TREPO - THREE RIVERS PARK

362 SW RIVERSIDE AVE., FT. WHITE

ADDENDUM LETTER

The following is an addendum to the plans signed and sealed on 24 MAY 2023:

TYPICAL SECTION (N.T.S.)

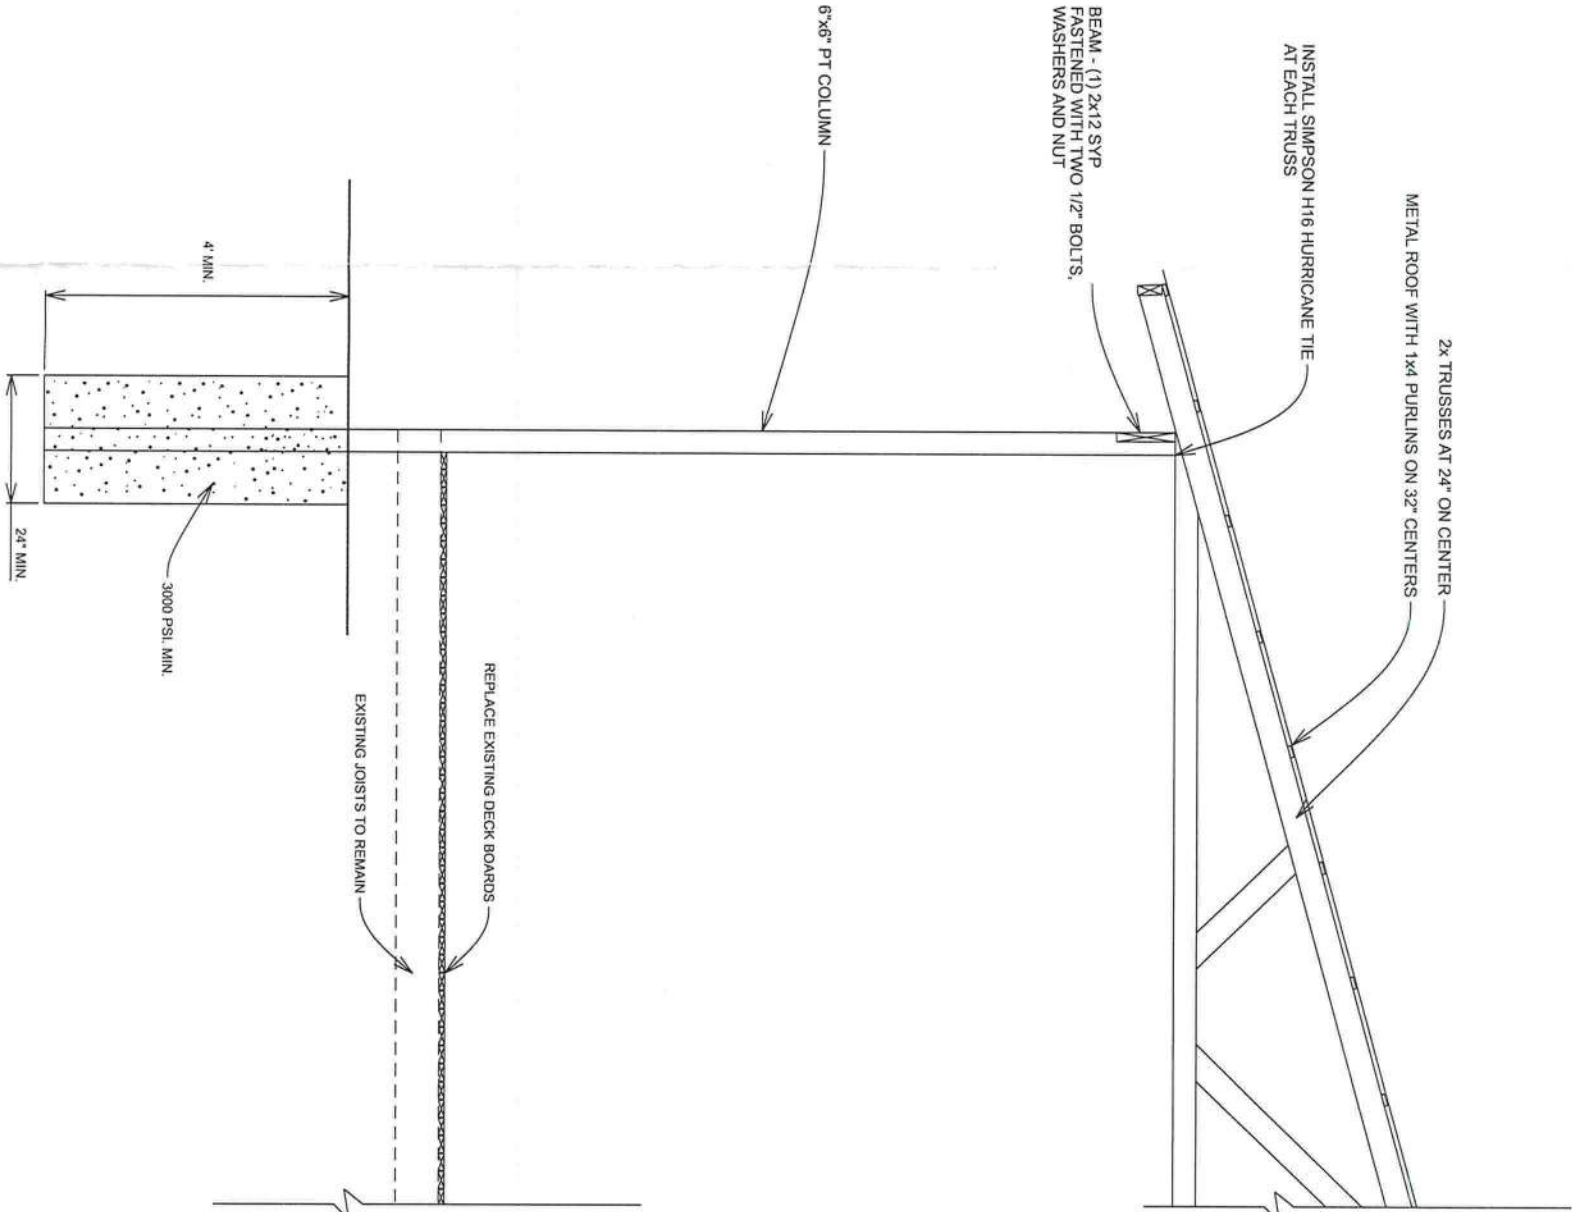
1. Construct trusses to match existing structure. Install Simpson HTP Tie Plate on both sides of each truss member to member connection. Fasten with either 0.148 x 1 ½" nails or SD Connector Screw #9 x 1 ½". Install Simpson H16 hurricane tie at each truss to beam connection.
